STAFF RECOMMENDATION
2703 Woodlawn Drive
October 16, 2019

Application: New Construction—Addition and Outbuilding; Partial Demolition
District: Hillsboro-West End Neighborhood Conservation Zoning Overlay
Council District: 18
Base Zoning: RS7.5
Map and Parcel Number: 104150041600
Applicant: Brent Legendre, Scott Wilson Architect LLC
Project Lead: Melissa Sajid, melissa.sajid@nashville.gov

Description of Project: Application is to construct a rear addition and outbuilding. The request also includes partial demolition of existing window and door openings on the historic house and demolition of an existing rear addition.

Figure 2. Front façade

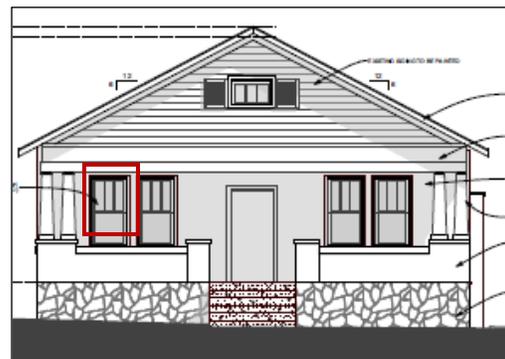
Partial demolition: The applicant proposes to convert the door to the left of the principal entrance to a window to match the paired windows to the right of the front door (Figures 1 and 2). The house is currently classified as a duplex. According to city directories, the house was likely a single-family home from at least 1944 – 1951 as a single occupant was listed. For this reason, staff finds that the house likely had one principle entrance and was likely symmetrical in design with a paired window on each side of the door. This is further supported

by the height of the door opening. The opening is the same height as the other windows on the front façade but has been filled in at the top to accommodate the door. For these reasons, staff finds that it's appropriate to convert the door to a window to match the existing paired window on the front façade.

Figure 3. Right elevation.

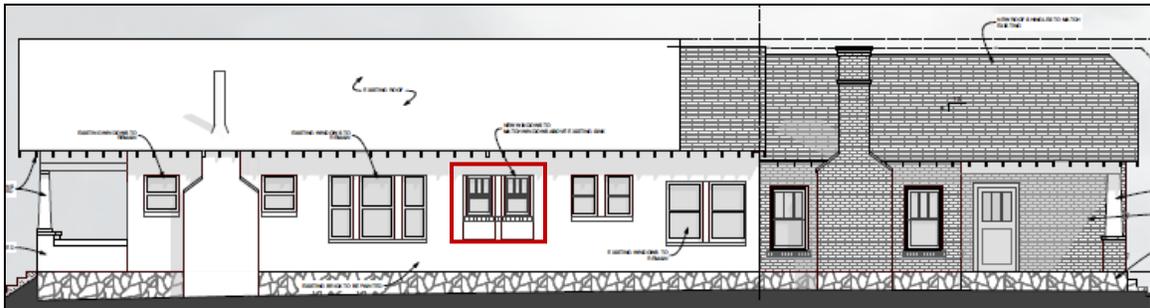
The application also includes truncating paired windows on both side façades (Figures 3 and 4). Staff finds that it can be appropriate to shorten both paired windows given the location on the side façades at or beyond the midpoint and since there will still be vertically oriented paired windows in both locations.

Figure 6. 1968 footprint

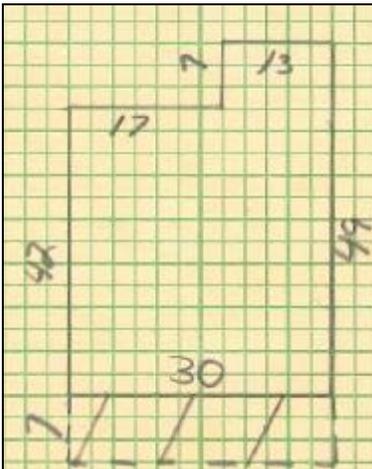
Existing covered and screened porches on the rear façade (Figure 5) will be demolished to allow for the construction of the new rear addition. The screened porch was not present in 1968 as it does not appear on the Property Assessor's card from that year (Figures 6 and 7) and, therefore, is appropriate to demolish. It is possible that the covered porch may have been original to the house; however, staff finds that its demolition is appropriate since it is located at the rear and not a character-defining feature of the historic house.

Staff finds that the proposed partial demolition meets Section III.B.2 for appropriate demolition and does not meet section III.B.1 for inappropriate demolition.

GARAGE ELEVATIONS

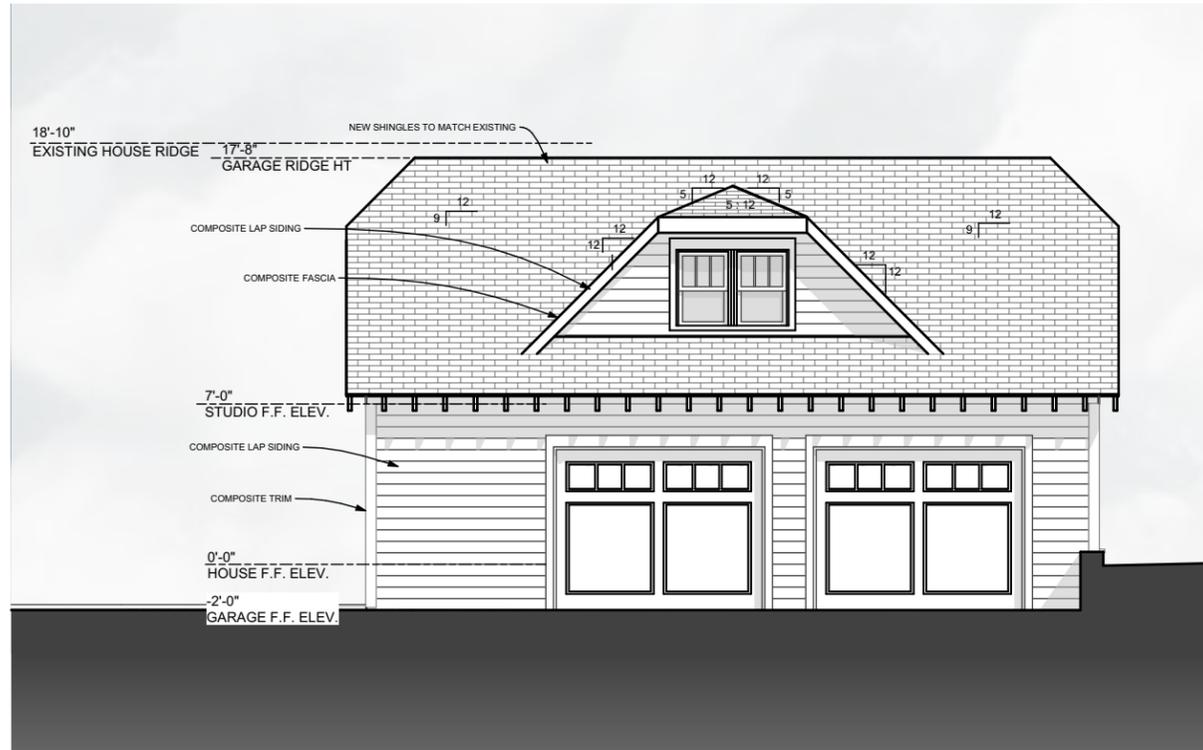
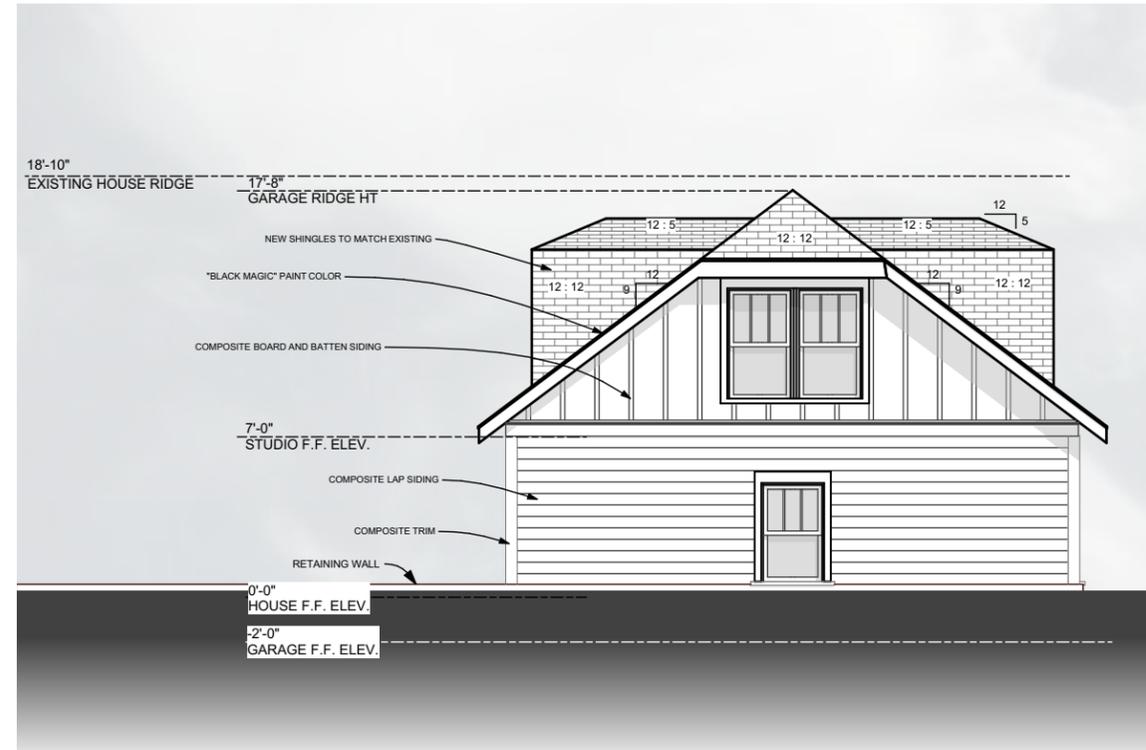
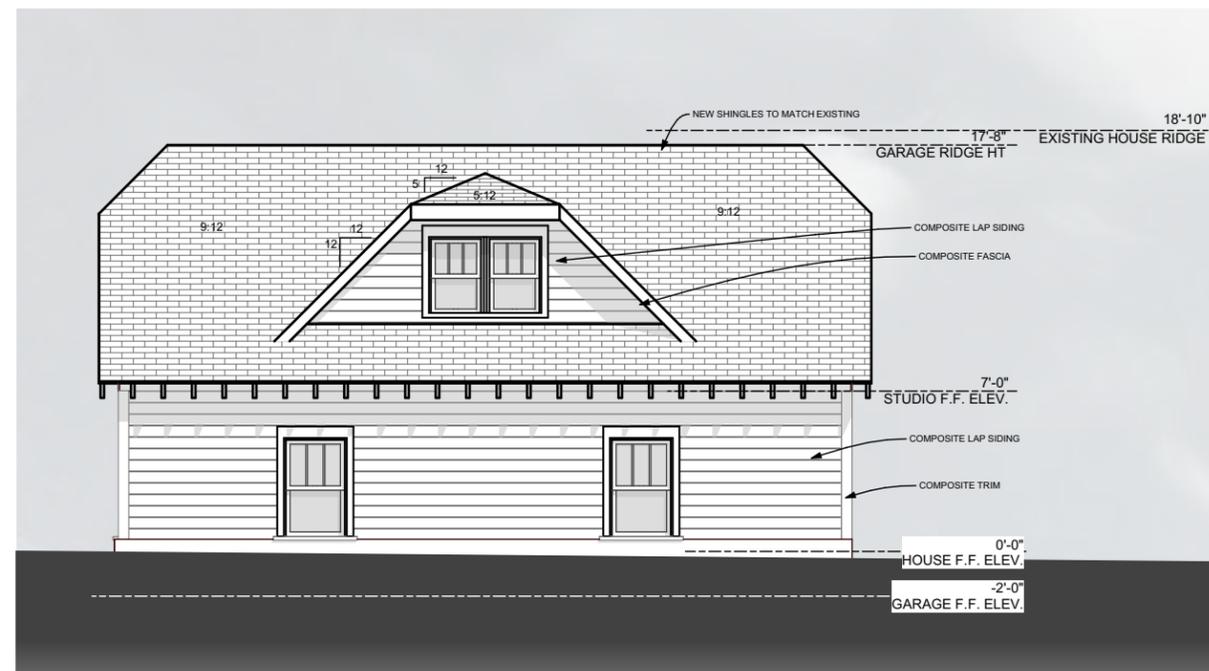
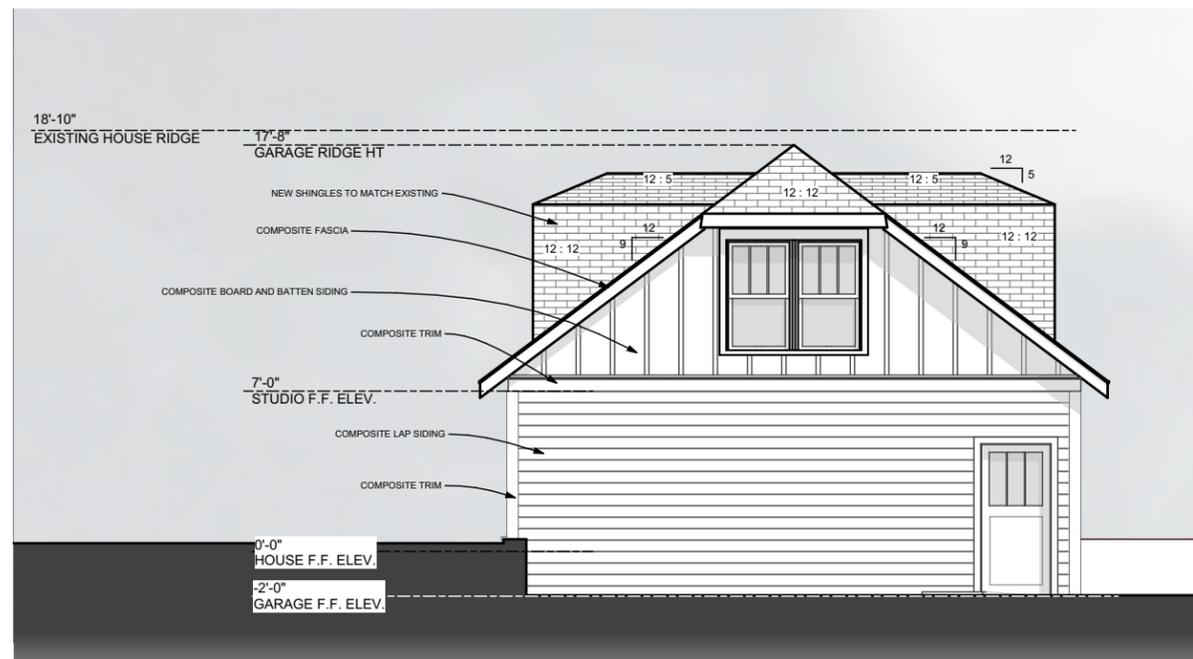
Design Standards: The outbuilding is one and one-half stories and no taller than the historic house. The outbuilding has a simple design that is appropriate for an accessory structure. Staff finds that the proposed design meets Section II.B.h.1 of the design guidelines.

With the condition that all siding be smooth faced with a maximum reveal of five inches (5”) and staff’s final approval of all windows and doors, staff finds that the known materials meet Section II.B.h.1 of the design guidelines.
